Expanded Comments on the City of Boston Placemaking Study

Comments submitted to the BRA on July 14, 2016

A Better City is pleased to comment on the Placemaking Study conducted by the City of Boston and its consultants, supported by MassDOT, as presented to the I-90 Allston Interchange Task Force on June 27, 2016 and further discussed with the Task Force on July 13, 2016. The Placemaking Study places due emphasis on the Interchange project as both a transportation initiative and a community development opportunity that over time will immeasurably improve the immediate Allston Neighborhood as well as create a vital new quarter for the City and region as a whole.

Proposed Daylighted Salt Creek with pedestrian and bike access
Source: Boston Globe "At Beacon Yards, Here Comes the Neighborhood"

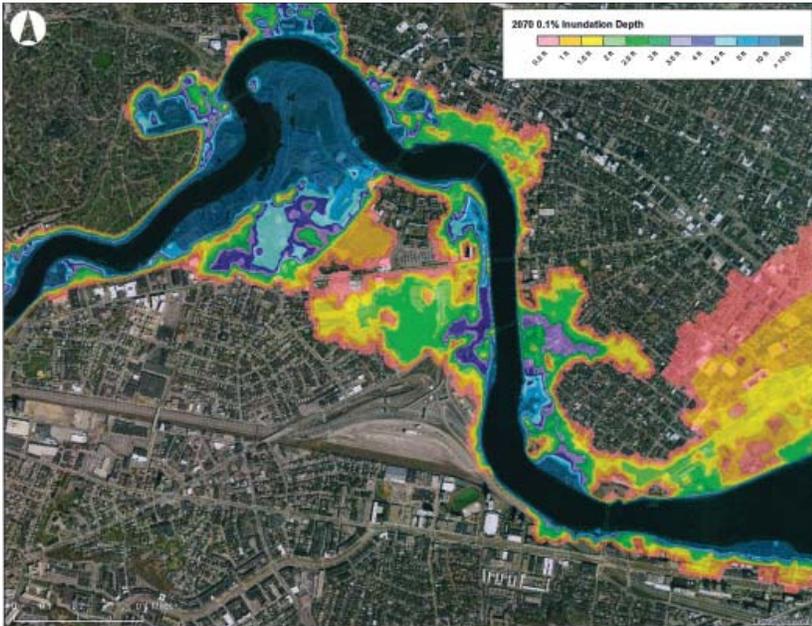
- Daylight Salt Creek to capture and treat stormwater flows and provide capacity for larger volumes
- Meet phosphorus reduction requirements for stormwater runoff to reduce nutrient pollution
- Create open space to absorb excess precipitation and provide flood storage
- Provide safe and inviting public access to the riverfront via pedestrian and bike ways
